Sent: 2/03/2020 7:40:33 AM
Subject: Re: 26 Ralston Road, Palm Beach, NSW 2108 DA 2020/0096 WRITTEN SUBMISSION: LETTER OF OBJECTION Submission: Plank
Attachments: 020220 Submission Plank 0096.docx;

26 Ralston Road, Palm Beach, NSW 2108

DA 2020/0096

WRITTEN SUBMISSION: LETTER OF OBJECTION

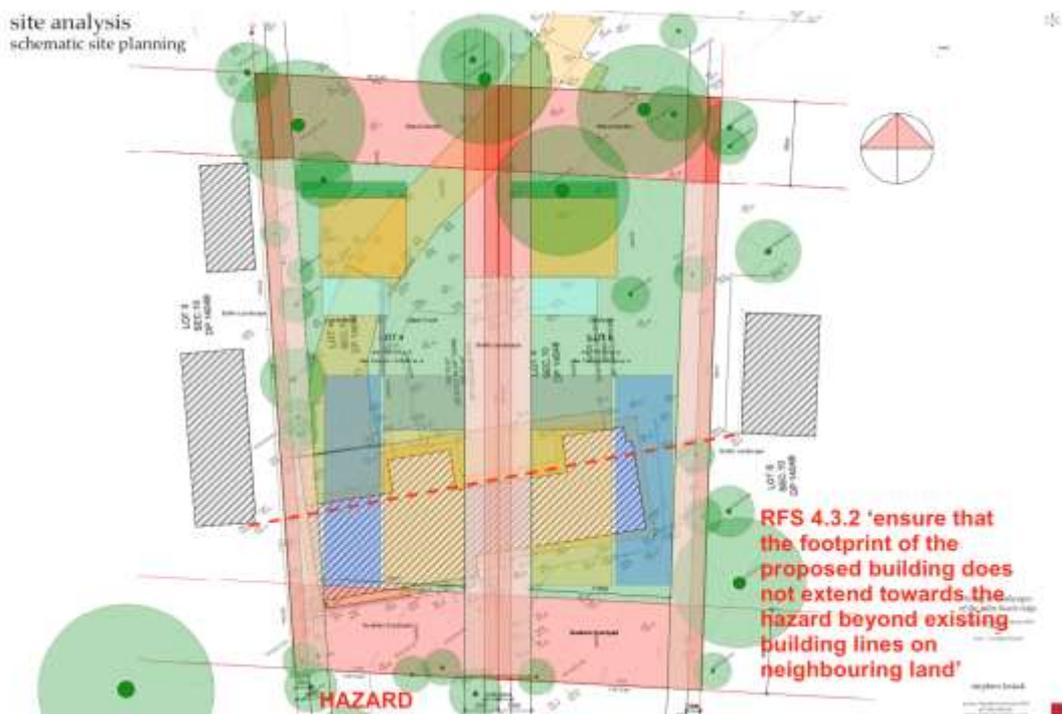
I contend that the footprint of the proposed building does extend towards the hazard beyond existing building lines on neighbouring land. The rear alignment should follow approximately a rear setback dimension of 11.5m for #28 Ralston to 19.9m for #26 Ralston, and accord with the survey set out. The proposed rear setback is only 4.5m to the concrete eaves detail.

The non-compliance with the above Objectives, and the poor architectural response to PBP, gives considerable grounds for concern.

View Point from 8 Ebor Road Palm Beach

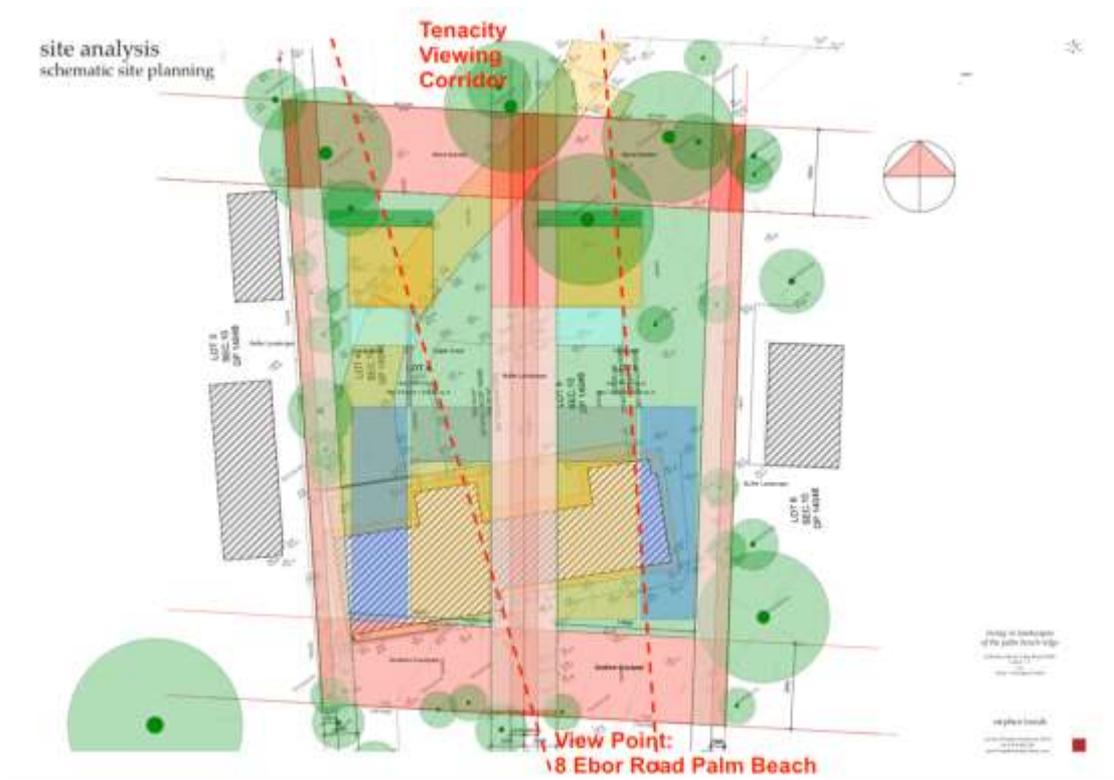
The proposed development will take away views for its own benefit.

The view from my windows and deck towards the water view, and the land-water interface will be lost.

The existing view is a 'moving landscape', rather than just a 'scenic outlook', given the activity on the water.

The extent of view loss is severe to devastating, and the features lost are considered to be valued as identified in Step 1 of *Tenacity*.
